Site Plan Review Committee (SPRC)
Staff Report for
1840 Wilson Blvd. – NSTA Site

NSTA Site (SP #478)
1840 Wilson Blvd. (1805 Clarendon Blvd.)
(RPC#s 17-011-057, -056)

SUMMARY: The applicant, Fortis, proposes a Site Plan Amendment (#382) to develop the site (“NSTA Site”) with a 7-story mixed-use building, consisting of ground floor retail and residential dwelling units above.

Rhodes Street Section looking North (Left); Rhodes Street Sidewalk Section (Right)

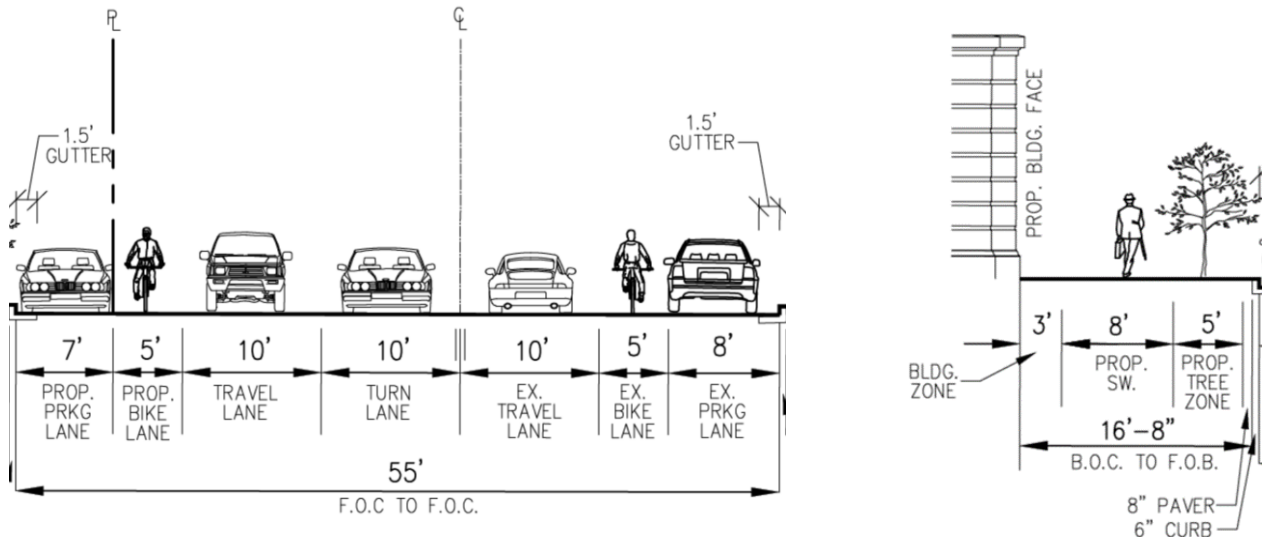
In the site vicinity, North Rhodes Street meets parts of this typology. While it is in a medium to high densely populated and travel area and has transit facilities nearby, it has limited bicycle facilities adjacent to the site. The existing lane configurations will be maintained though the curb-to-curb width will be reduced from 55.7 feet to 55 feet. Within the curb-to-curb width the applicant is proposing a new southbound bike lane previously treated as a shared-use lane with a southbound motor vehicle lane. It’s sidewalk is an 8’ width with no tree pits or landscape buffer but there are numerous sign posts. There are no driveways along North Rhodes Street adjacent to site and none are proposed by the applicant. The street sections proposed by this project show to increase the total streetscape width to 16’8”, including 5’ tree pits with an 8” step-off area, 8’ clear sidewalk, and 3’ shy zone. The R-B Corridor streetscape plans call for a 16’8” total streetscape including 5’x8’ (or larger) tree pits, which the applicant is meeting. The proposed sections are as shown below.

Clarendon Blvd Street Section looking East (Left); Clarendon Blvd Sidewalk Section (Right)

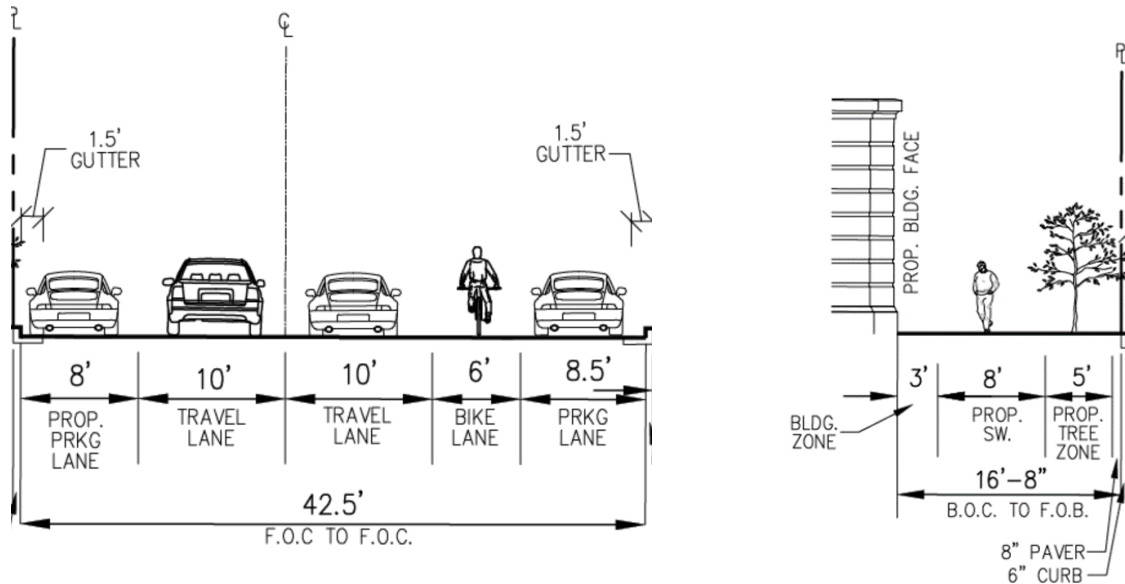
In the site vicinity, Clarendon Boulevard fits this typology as it serves a densely populated and highly traveled area with both transit and bicycle facilities provided within the street right-of-way. The existing lane configurations will be maintained though the curb-to-curb width will be reduced from 47.2 feet to 42.5 feet. At the intersection with North Rhodes Street the applicant proposes a curb extension. Clarendon Boulevard’s sidewalk along the site’s frontage vary in width from a suitable width (16’) to barely adequate (6’). Along the site’s frontage on Clarendon Boulevard there are three existing driveways serving the existing surface parking lot, loading dock, and alley. The street sections proposed by this project show to increase the total streetscape width to 16’8”, including 5’ tree pits with an 8” step-off area, 8’ clear sidewalk, and a 3’ shy zone. The applicant is proposing to remove two existing driveways serving the surface parking lot and loading dock and will maintain the alley driveway. The R-B Corridor streetscape plans call for a 16’8” total streetscape including

5'x8' (or larger) tree pits, which the applicant is meeting. The proposed sections are as shown below.

CORNER OF WILSON AND RHODES

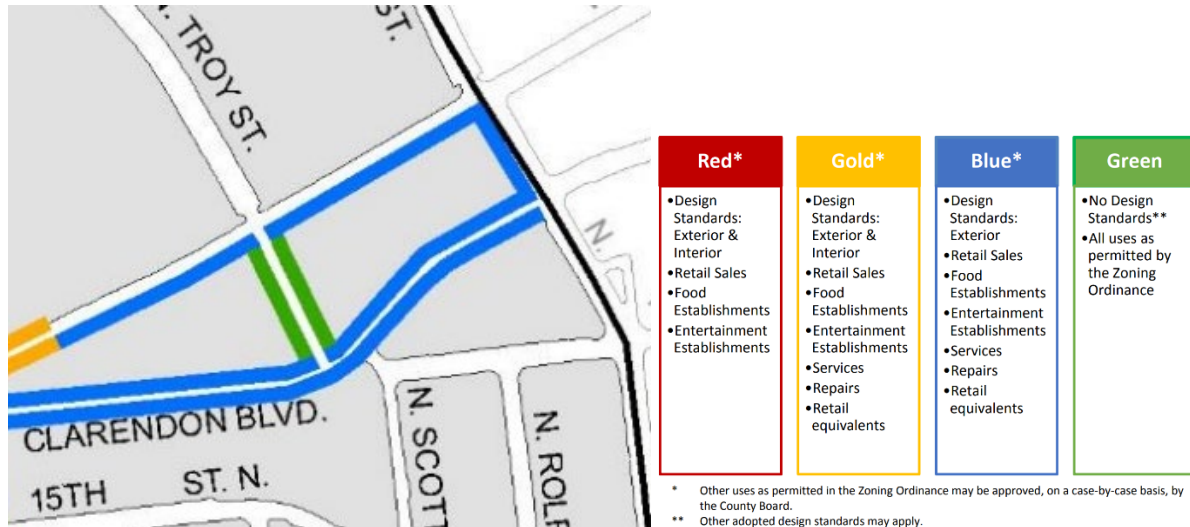
Architecture: The corners of the building at Clarendon and Wilson Boulevards and Rhodes Street are designated for special architectural treatment. The applicant is proposing a rounded corner at Wilson Boulevard and Rhodes Street to pay homage to the rounded façade on the existing Rhodeside Grill building. Staff continues to analyze the architecture and work with the applicant throughout the public review process.
